**Ordinary Meeting of Council Meeting No. 11/13
TUESDAY, 28 MAY 2013**

19 WEST RYDE URBAN VILLAGE - ACCESS REPORT FOR EARLY OPENING OF BASEMENT CARPARKS

RE: WEST RYDE VILLAGE SQUARE - ACCESSIBILITY ISSUES REPORT

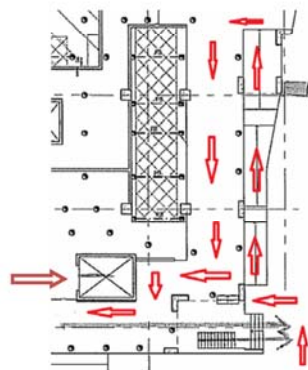
The question has been raised as to where would be the most appropriate means of pedestrian access to the car parking whilst the area is back propped and still under construction. After close consideration, MGAC is proposing that the most appropriate path of travel from the shopping centre to the basement car parking will be via the exist shopping centre stair/ramp - travel north (plan north) to the 1:14 ramp (facing Anthony Road) as shown below.

The drawing below shows the amount of propping to be moved to allow for a minimum 1500mm clear width (1800mm in width & 2000mm head height preferred) as to accommodate the anticipated volume of pedestrian traffic (wheelchair users, mothers with prams/trolleys).

From this point of travel, a relatively short distance will be achieved via the passenger lift to the basement car parking. This will satisfy BCA, AS1428.1 AS2890.1 (parking for people with disabilities) and the DDA.

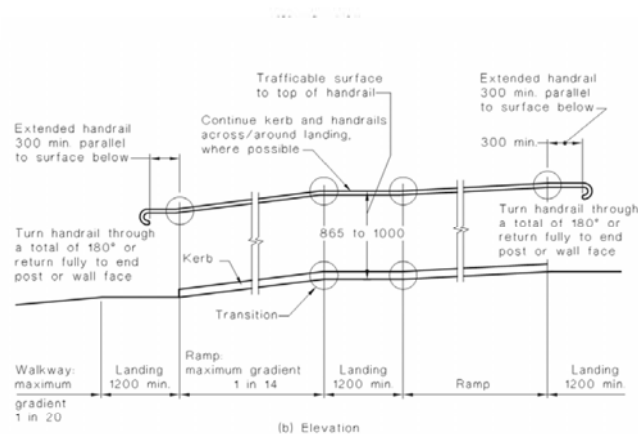
1. Ensure the ramp in question has a gradient fall no steeper than 1:14 in accordance with AS1428.1.
2. A continuous handrail shall be provided on both side of the ramp compliant with AS1428.1 as follows:
 - Ensure circular/elliptical handrails have 30-50mm diameter, with 270 degree clear arc around top of handrail (extending for 600mm min. height) compliant with AS1428.1 Fig.29.
 - Ensure handrails are installed between 865mm – 1000mm height above step nosing or FFL ramp surface, compliant with AS1428.1 Clause 12(d).
 - Ensure handrails are installed no less than 50mm away from an adjacent side wall, compliant with AS1428.1 Clause 12(h).
 - Ensure that the handrail at the top or bottom of a ramp extends (on the horizontal) 300mm past ramp then turns 180 degrees downwards or returns fully to post /wall, compliant with AS1428.1 Clause 10.3(h), fig14, 15.

FIGURE 2.3 EXAMPLE OF TWO PARKING SPACES WITH A COMMON SHARED AREA—DIMENSIONS FOR AUSTRALIA ONLY*

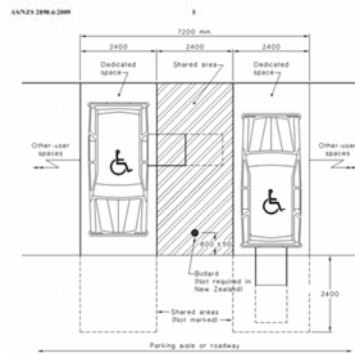
- Provide 2% of total car bays to be designated as accessible car bays.
 - Accessible car bays to have 2400mm min. width x 5400mm min. length adjacent to shared zone with 2400mm min. width x 5400mm min. length with bollard installed at start of shared zone in accordance with AS2890.6 fig 2.2, 2.3.

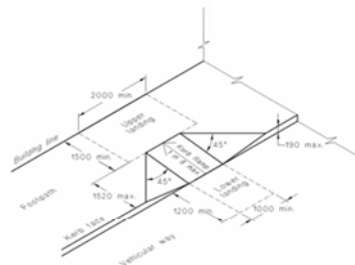
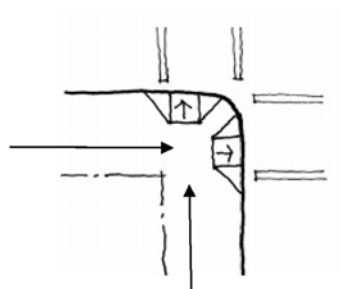
According to the site inspection the kerb ramp at car park entrances (Chatham exit and new Market Street entrance) lacks appropriate access according to AS1428.1.

- (i) Ensure kerb ramps have 1:8 gradient, 190mm max. Height, 1000mm min. width and 1520mm max. length, compliant with AS1428.1 fig 23.

- (ii) Kerb ramps shall be placed in line with the direction travelled when crossing the street.

FIGURE 13: TRAFFIC CONTROL PLAN

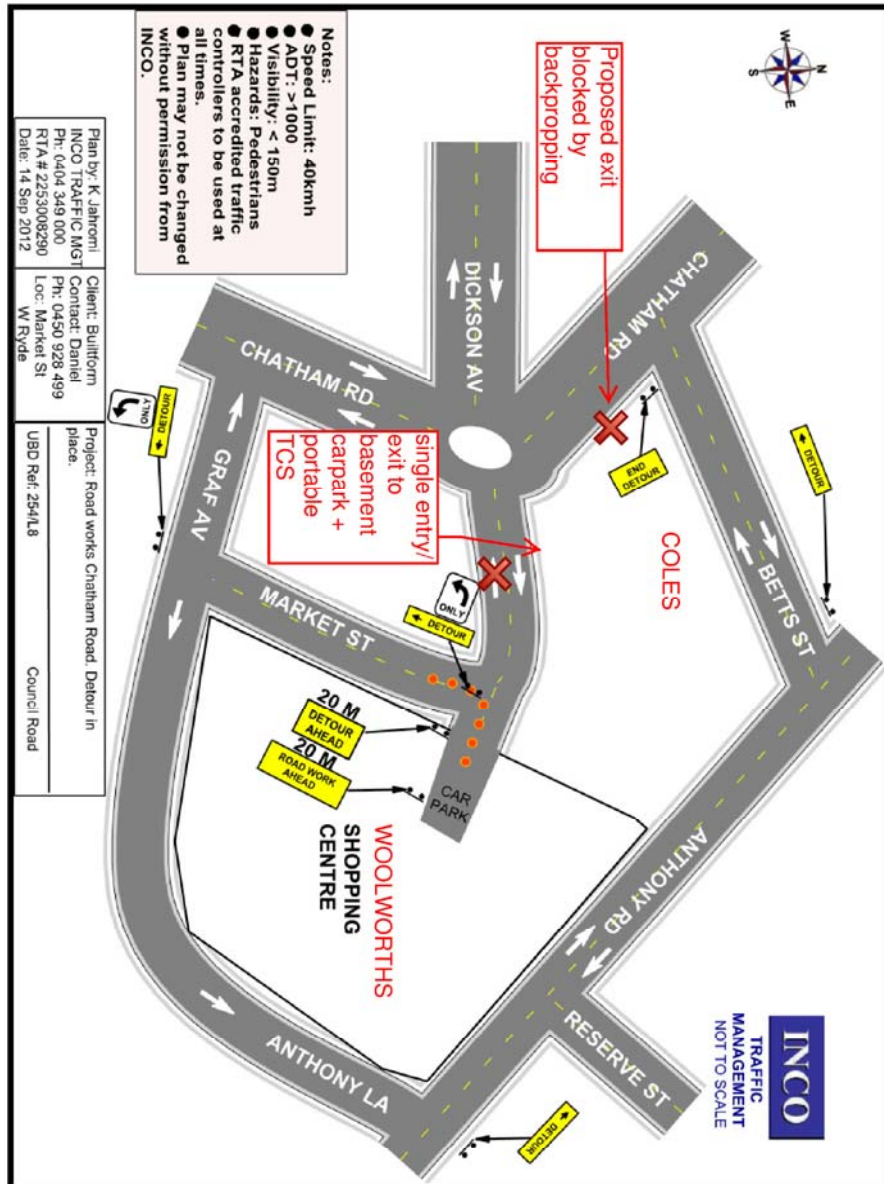
Strategies to manage the 'temporary' single entry / exit are use of traffic control to safely manage vehicle movement. Preliminary investigation shows the driveway entry width is 4.5m and this is insufficient to meet minimum requirements for two way access (2 lanes x 2.8m = 5.6m minimum width).

Given two way access cannot be safely achieved then portable traffic control signals (TCS) may need to be used. A stop / go arrangement would allow single lane access to the carpark with New Market Street operating in a one-way direction (easterly). It is recommended that a microwave detector be used allow dynamic phasing of the TCS.

Further investigation into location of the portable TCS is required to establish if they can fit in the limited available space between the driveway access ramp and New Market Street. Checking of turning paths for vehicles exiting left on New Market Street also needs to be carried out.
